ADDENDUM NUMBER TWO

**HCPS WAREHOUSE BUILDING
HENDERSON COUNTY/HENDERSON COUNTY PUBLIC SCHOOLS**

MLA PROJECT NUMBER: 21010

DATE OF ISSUE: August 25, 2021

3 ALTERNATE 1 EAST ELEVATION
 SCALE: 1/8" = 1'-0"

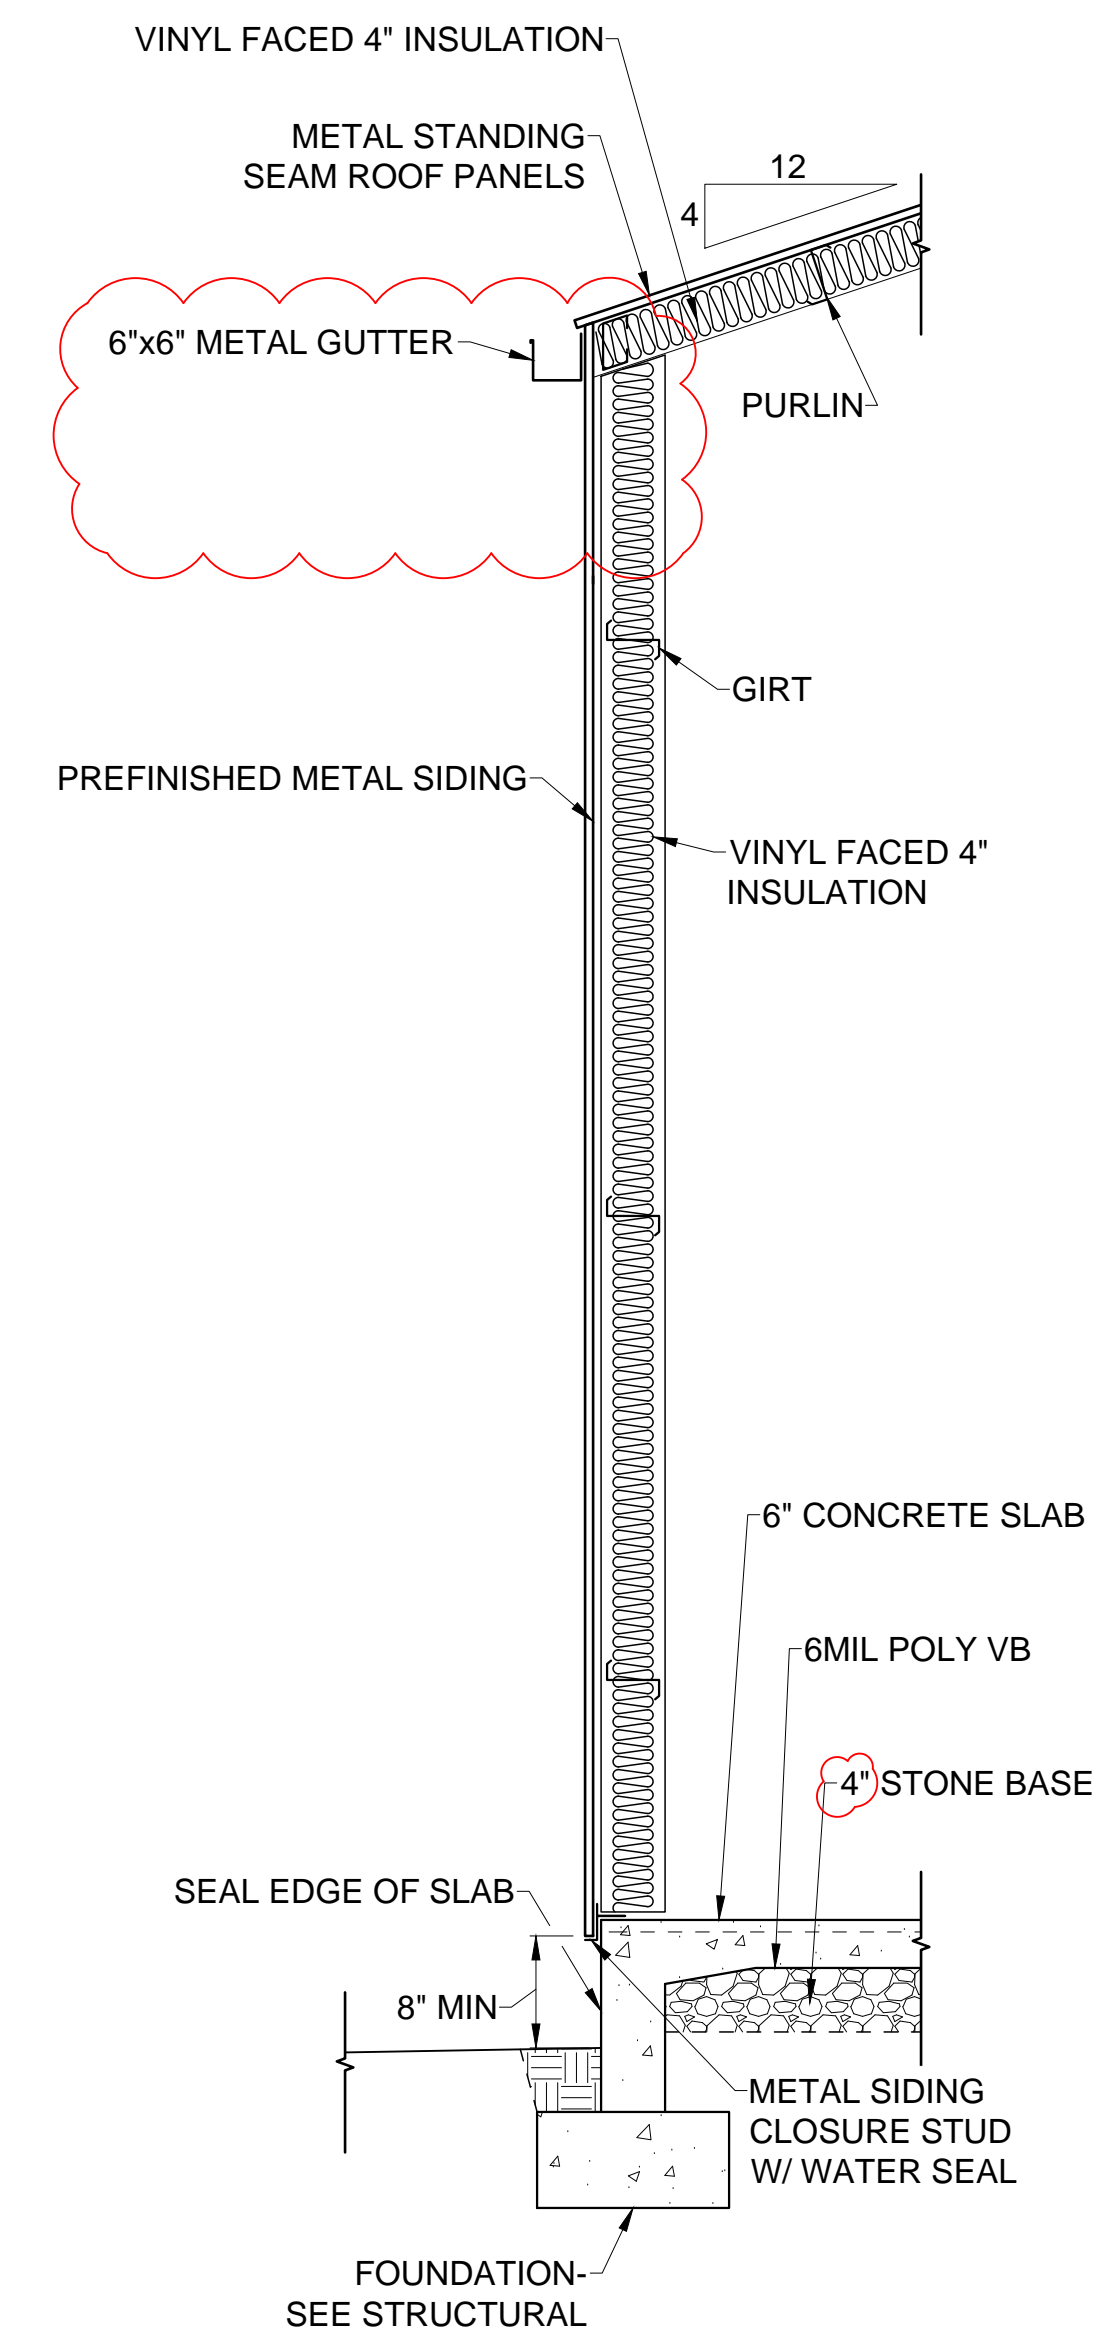
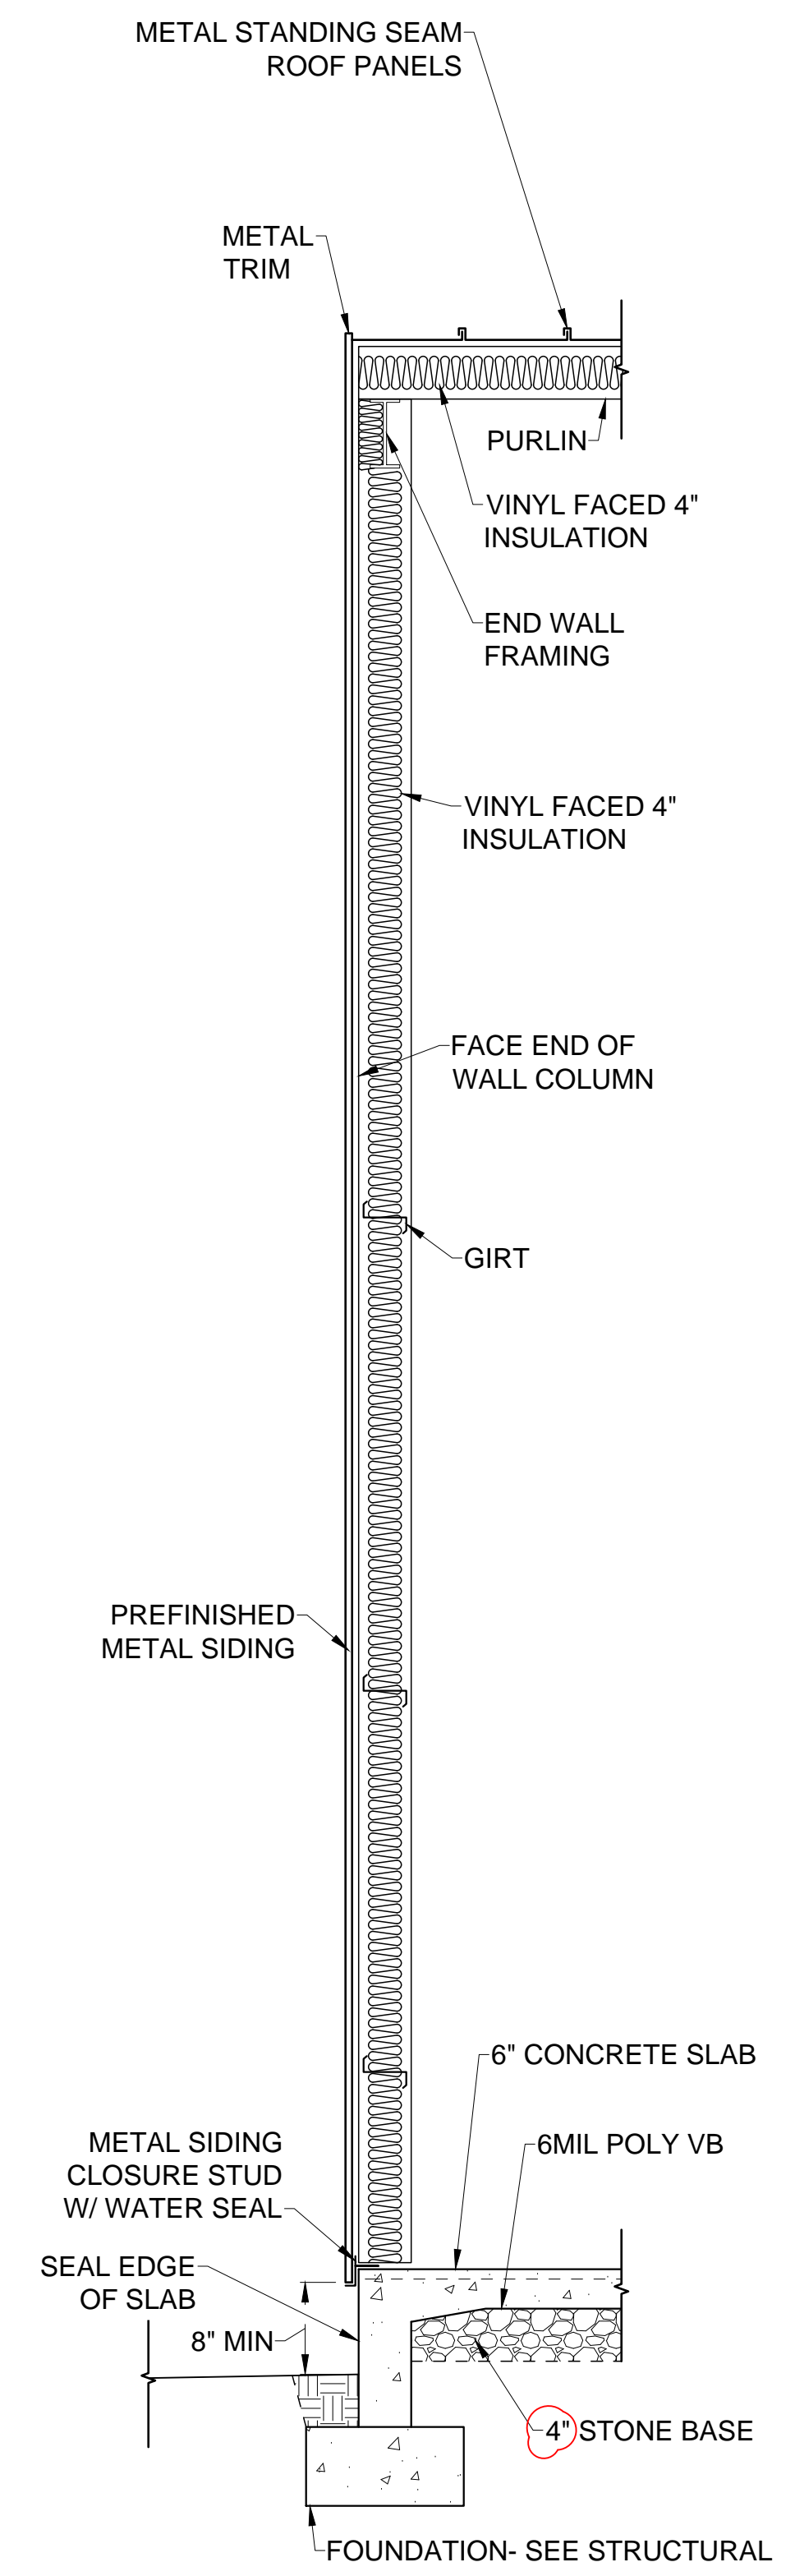
- Top soil removed for clearing is acceptable for outside fill
 - Exterior concrete clarifications and note
2. A101/ A201:
 - The soffit is deleted from the building
 - The ridge vent is deleted from the building
 - The passage door location is corrected on Alternate 1 plan
 - Concrete floor stone base thickness changed to 4"
 3. 4-5/A201: revise 6 mil VB to 10 mil VB
 4. E1/E2/ E3/ E4:
 - An exhaust fan is added to the south louvers and specified on Lighting Fixture Schedule
 - The passage door locations are corrected on Alternate 1 plan
 - The meter box and panel are re-located to the south corner wall
 - Panel A is revised to include EF's
